Ref: BHE/PW/PUR/KORSR1-CRH/1293/Corrigendum-01

Sub: Corrigendum -01 Issue of Clarification

JOB: PROVIDING SERVICES OF TOWER CRANE ON MONTHLY HIRING BASIS FOR RENOVATION & RETROFITTING OF EXISTING ELECTROSTATIC PRECIPITATORS & DUCTS WORK AT STAGE- I&II (3x 200 MW + 3x500 MW) NTPC, KORBA SUPER THERMAL POWER STATION

Tender Specification Number: BHE/PW/PUR/KORSR1-CRH/1293

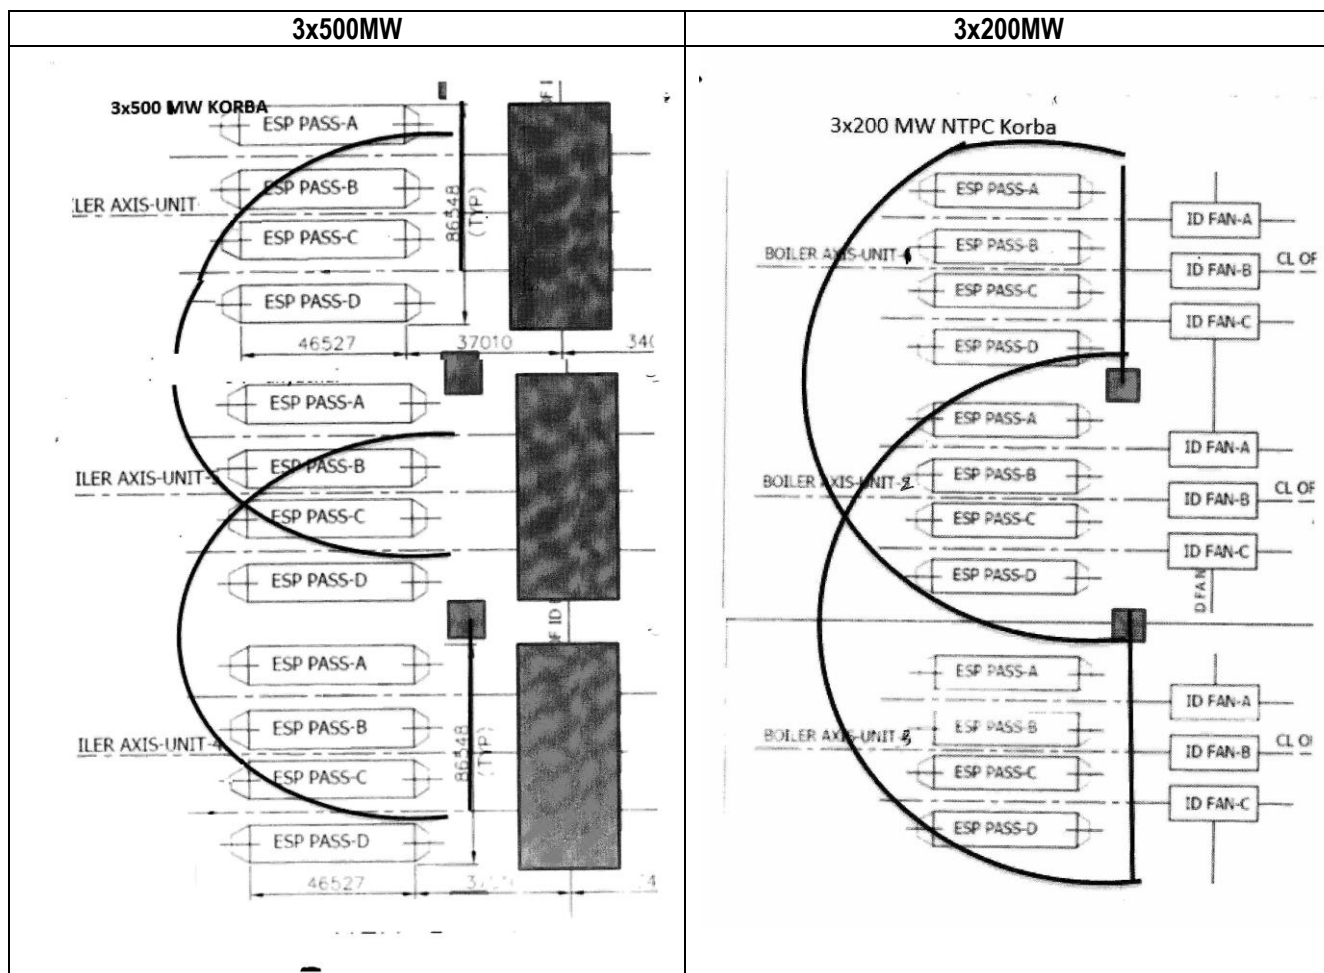
QUERY 5: CLARIFICATIONS RELATED TO L1 PRICE AND REVERSE AUCTION PROCESS – As per tender, foundation (if required) will be provided by BHEL. The cost of such foundation (for bidding purpose and calculating L-1 rate only) for each vendor will be communicated by BHEL to the vendors. Please mention no. of local shiftings planned for the site as the total cost of foundation which will get added will vary in direct proportion to the number of times shifting will be done. Further, it is mentioned that the L-1 rate shall be calculated as landed cost to BHEL (including cost of foundation). Therefore, the reverse auction process for each vendor will need to be entered as their price bid + their foundation cost as communicated by BHEL. Please confirm.

CLARIFICATION 5: Request of bidder is noted. The no. of locations for erecting tower crane planned for 3x200MW ESP structure shall be Two (02) nos. (which means one shifting). Similarly, the no. of locations for erecting tower crane planned for 3x500MW ESP structure shall also be Two (02) nos. (which means one shifting). Refer the below drawings for reference for tentative positions of the cranes shown by boxes (□)
